**CERTIFICATE OF APPROPRIATENESS**

**Property:** 620 Columbia Street, Lot 17, Block 281, Houston Heights Subdivision. The property includes a historic 1,279 square foot one-story wood frame single-family residence and rear detached garage situated on a 6,600 square foot (50' x 132') interior lot.

**Proposal:** Alteration – Addition

WEST ELEVATION – FRONT FACING COLUMBIA STREET

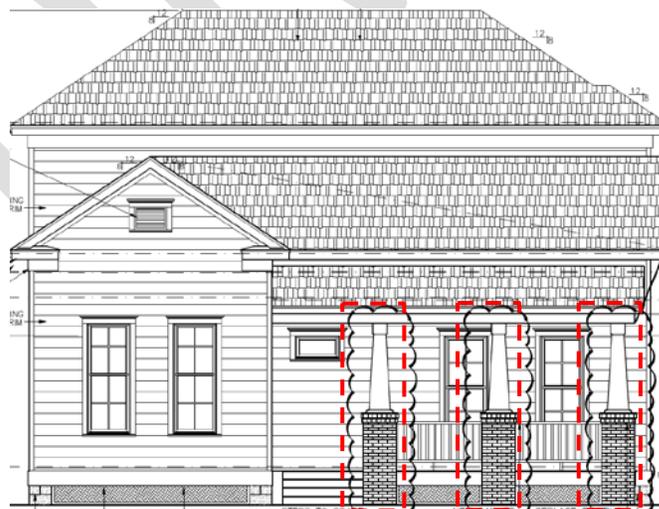
- Replace the three existing wood turned columns with square wood tapered columns with brick bases.
- Replace the existing 2-lite front entry door with a craftsman style, 3-lite wood paneled entry door.
- Install a 1x12 band board on the north, south and east elevations.
- Relocate and install windows on the north, south, and east elevations of the proposed 2-story addition.
- Change a proposed divided lite french doors and two 1-over-1 sash windows to three divided lite entry doors on the rear elevation of the proposed addition.
- Enlarge the proposed rear porch from 8' deep to 12' deep.

**Denial of: Replacement of the existing turned wood columns and 2-lite front entry door and installation of 1x12 band board on existing residence.**

|                                     | <input checked="" type="checkbox"/> | <input type="checkbox"/> | (1) The proposed activity must retain and preserve the historical character of the property;<br><i>The replacement of the existing 2-lite front door with the proposed craftsman style entry door and replacement of the turned columns with square tapered columns and brick bases significantly alters the character of the 1910 Queen Anne Cottage style residence.</i>   |
| <input type="checkbox"/>            | <input checked="" type="checkbox"/> | <input type="checkbox"/> | (3) The proposed activity must recognize the building, structure, object or site as a product of its own time and avoid alterations that seek to create an earlier or later appearance;<br><i>The installation of the craftsman style entry door, square tapered columns, and 1x12 band board introduce architectural elements that were never present on the residence and are not compatible with the character of the 1910 Queen Anne residence. The installation of these features creates a false sense of history.</i>   |
| <input type="checkbox"/>            | <input checked="" type="checkbox"/> | <input type="checkbox"/> | (4) The proposed activity must preserve the distinguishing qualities or character of the building, structure, object or site and its environment;<br><i>The removal of the existing wood turned columns and existing 2-lite entry door results in the loss of distinguishing qualities that contribute to the character of the 1910 residence.</i>   |
| <input type="checkbox"/>            | <input checked="" type="checkbox"/> | <input type="checkbox"/> | (5) The proposed activity must maintain or replicate distinctive stylistic exterior features or examples of skilled craftsmanship that characterize the building, structure, object or site;<br><i>The replacement of the turned columns with square tapered columns with brick bases and replacement of the 2-lite front door with a 3-lite wood paneled front door results in the loss of significant stylistic exterior features that characterize the 1910 Queen Anne residence.</i>   |
| <input type="checkbox"/>            | <input checked="" type="checkbox"/> | <input type="checkbox"/> | (8) Proposed additions or alterations must be done in a manner that, if removed in the future, would leave unimpaired the essential form and integrity of the building, structure, object or site;<br><i>The removal of the existing turned columns and entry door results in the significant loss of material that contributes to the character and integrity of the contributing residence.</i>  |
| <input type="checkbox"/>            | <input checked="" type="checkbox"/> | <input type="checkbox"/> | (9) The proposed design for any exterior alterations or addition must not destroy significant historical, architectural or cultural material and must be compatible with the size, scale, material and character of the property and the area in which it is located;<br><i>The replacement of the existing front door and turned columns with a 3-lite front door and tapered columns with brick bases and the installation of the 1x12 band board on the existing residence introduces architectural elements that are typical of Craftsman style residence and not compatible</i> |

*with a contributing 1910 Queen Anne style residence.*

**Approval of: Relocation and installation of windows and doors on the proposed addition and installation of 1x12 band board on addition.**

**EAST (REAR) ELEVATION**

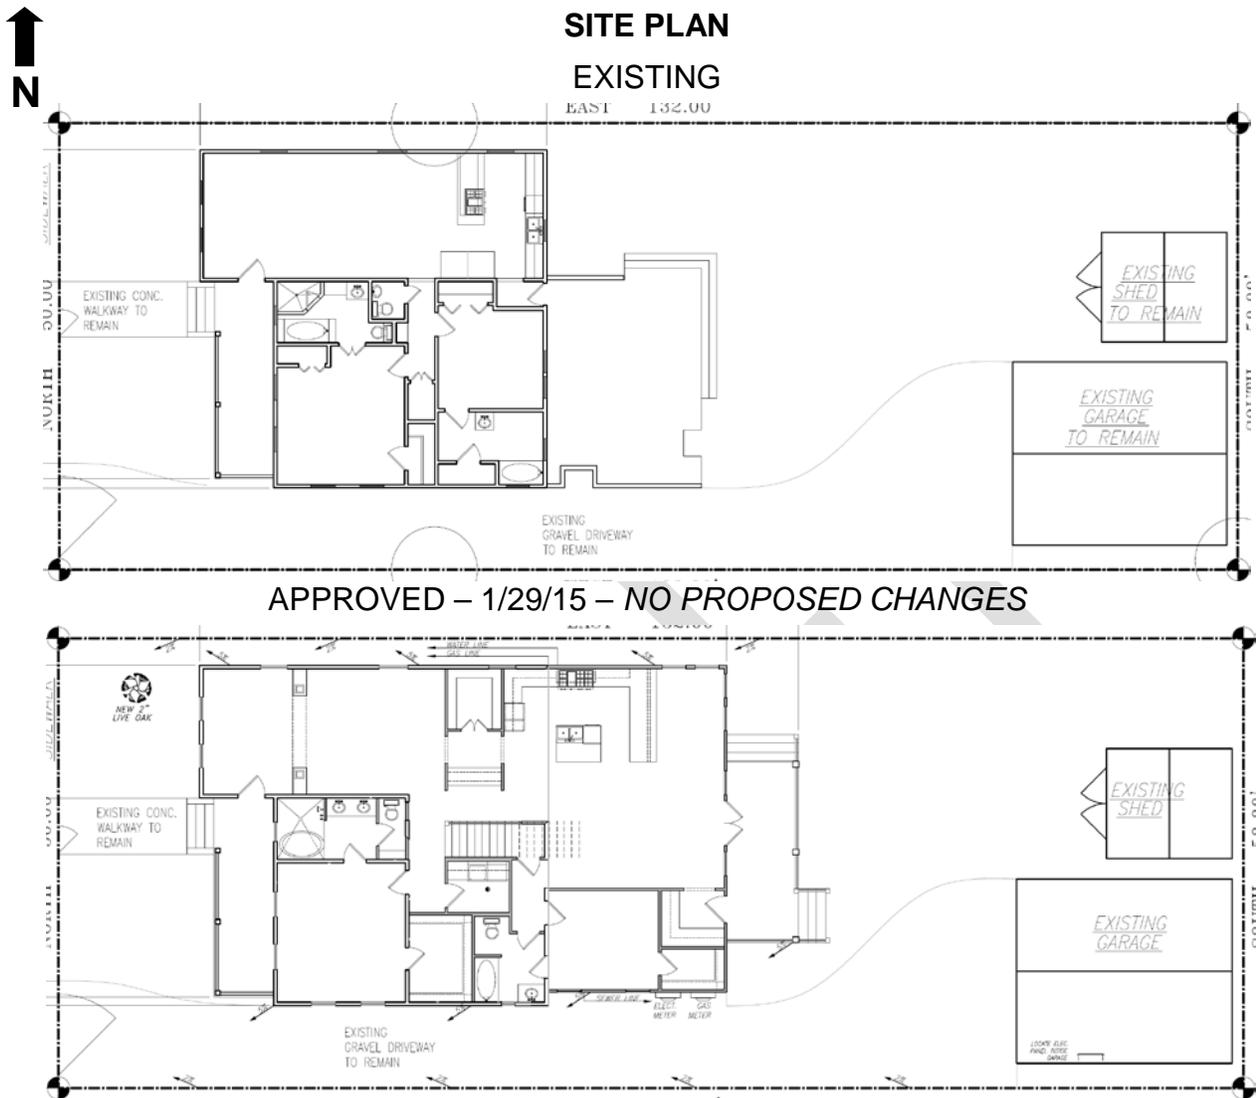
**Shape/Mass:** The residence measures 37'-10" wide, 38'-10" deep. 14'-4" to the eave, and 20'-8" to the ridge. The house will be raised 8" increasing the eave height to 15' and the ridge to 21'-4". The addition will begin 29'-8" from the front wall and will measure 37'-10" wide, 37'-1" deep, 22'-7" to the eave, and 30'-2". *The addition will feature a rear porch measuring 20'-2" wide and 12' deep (previously proposed 8' deep.)*
